Service Bulletin

Bulletin No.: 22-NA-003

Subject: Instrument Panel Cluster (IPC) Warning Lamps, Malfunction Indicator Lamp (MIL) Illuminated, Diesel Exhaust Fluid (DEF) Message Displayed - Various DTCs Set

4573222

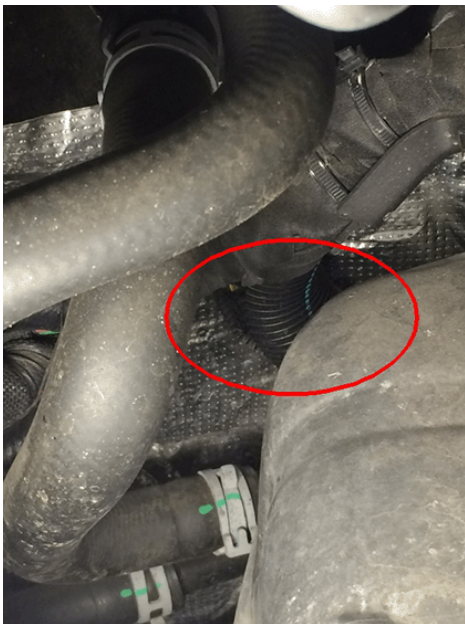
- B127E, C0306, C0321, C0398, C0800, P0071, P0072, P0091, P0117, P0119, P0340, P0341, P0406, P0483, P0522, P0628, P0641, P06A3, P0700, P20BB, P20BF, P227E, P24B1, U0073, U0077, U0121, U0131, U0140, U0151, U0415, U2099, U0401, U0415 and U0420.
- Serpentine Belt. The fan clutch wiring harness support bracket may be out of position allowing the harness to rub on the belt.

Concerns in the area of the serpentine belt may cause:

- Various IPC warning lights to illuminate.
- A crank no start concern.
- The MIL to illuminate.
- The engine may run rough or misfire.
- The Service Four Wheel Drive (4WD) light may illuminate.
- The Stabilitrak light may illuminate.
- The Air Conditioning (AC) may not cool or may blow hot air.

DTCs associated with chafing in this area may include:

- C0273, P0526, P0480, P0336, P0526, P0641 and P0651.

If you encounter these scenarios, inspect, repair (as necessary) and route the wiring harness away from these possible chafe points.

4573220

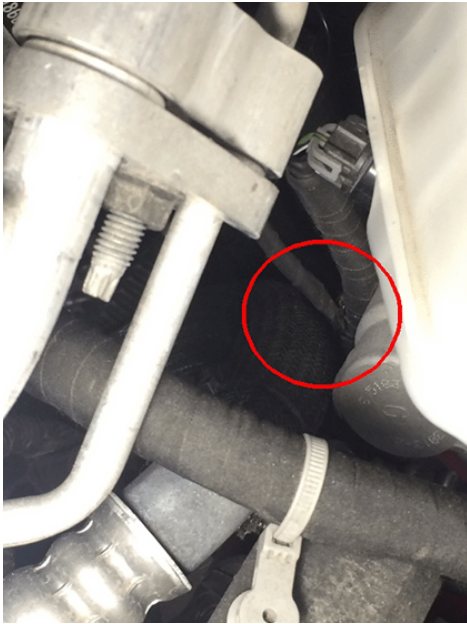
- P0201, P0202, P0203, P0204, P0392, P0401, P0420, P062D and U0073.
- Coolant pipe and clamp tabs between engine and cowl.

Concerns in the area of the coolant pipe / clamp / clamp tabs between engine and cowl may cause:

- Various IPC warning lights to illuminate.
- The Service Four Wheel Drive (4WD) light may illuminate.
- The Stabilitrak light may illuminate.
- The MIL to illuminate.

DTCs associated with chafing in the area may include:

- B1011, P0575, U0073, U0100, U0121, U0140, U0415 and U0420.
- Near the brake fluid level switch.

4573221

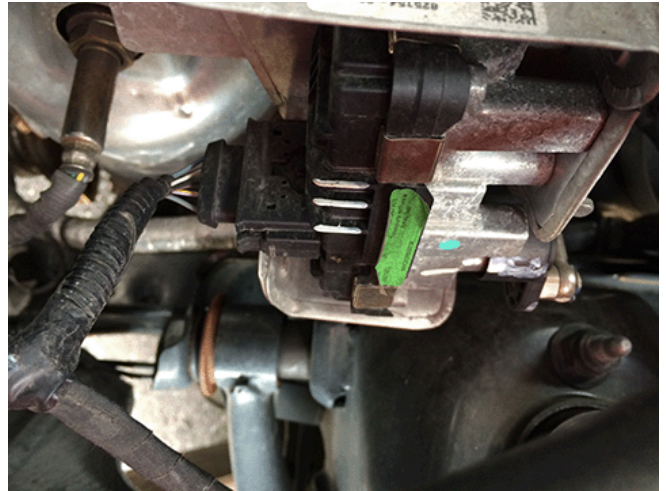
- C0273 and P0641.
- Transfer case encoder motor.

Concerns in the area near the encoder motor on the transfer case may cause:

- Various IPC warning lights to illuminate.

DTCs associated with chafing in this area may include:

- C0396.
- Turbocharger Vane Position Actuator Connector.
